Access Compliance Report

Public Rights-of-Way

(Curb Ramps)

Intersection ID: 14036	Main Street: COMMONWEALTH_AV	Cross Street: MORNINGSIDE_DR	Location: W
ADA ID: 9640D446D313	Ramp Type: Perp	Initial Pass/Fail: Fail	Overall Compliance: No
Codes/Mitigation Info/Possible Solution		Field Measurements/Component Compliance	
Severity Score: 33.75

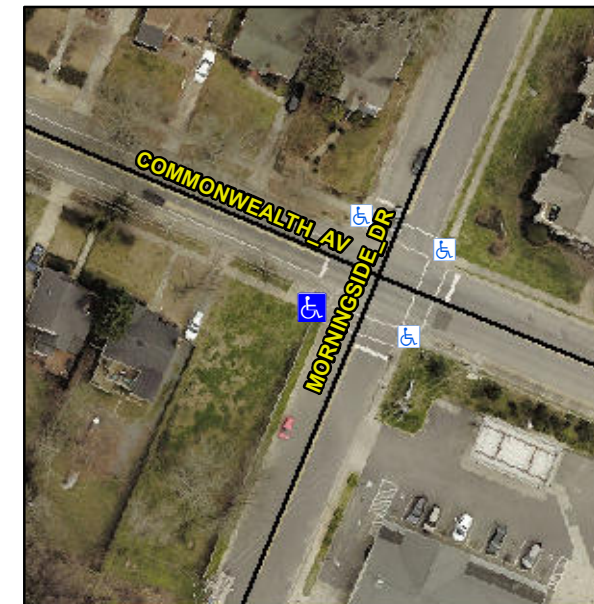
Not Found, R304.5.1, R304.2.2

Compliance	Description	Data	Compliance	Description	Data
N/A	Ramp Length (in)	54.0	No	Ramp Slope (%)	20.0
No	Ramp Width (in)	46.0	Yes	Ramp XSlope (%)	0.3
N/A	Flare Type LT	N/A	N/A	Flare Type RT	N/A
N/A	Flare Slope LT (%)	N/A	N/A	Flare Slope RT (%)	N/A
N/A	Flare Traversable LT?	N/A	N/A	Flare Traversable RT?	N/A
N/A	Landing Length (in)	N/A	N/A	DWS Provided?	N/A
N/A	Landing Width (in)	N/A	N/A	DWS Contrast?	N/A
N/A	Landing Slope (%)	N/A	N/A	DWS Length (in)	N/A
N/A	Landing X Slope (%)	N/A	N/A	DWS Full Width?	N/A
N/A	Landing Curb? (Y/N)	N/A	N/A	DWS Offset (in)	N/A
N/A	Shared Landing?	N/A			
N/A	Gutter Ponding?	N/A	N/A	Gutter Slope (%)	N/A
N/A	Gutter Lip Ht (in)	N/A	N/A	Gutter X Slope (%)	N/A
N/A	Painted X Walk1?	Yes	N/A	Painted X Walk2?	N/A
	X Walk 1 Direction	To SE		X Walk 2 Direction	N/A
N/A	X Walk 1 Width (in)	106.0	N/A	X Walk 2 Width (in)	N/A
	X Walk 1 Slope (%)	3.3		X Walk 2 Slope (%)	N/A
	X Walk 1 X Slope (%)	1.0		X Walk 2 X Slope (%)	N/A

Remove & Replace Entire Ramp.
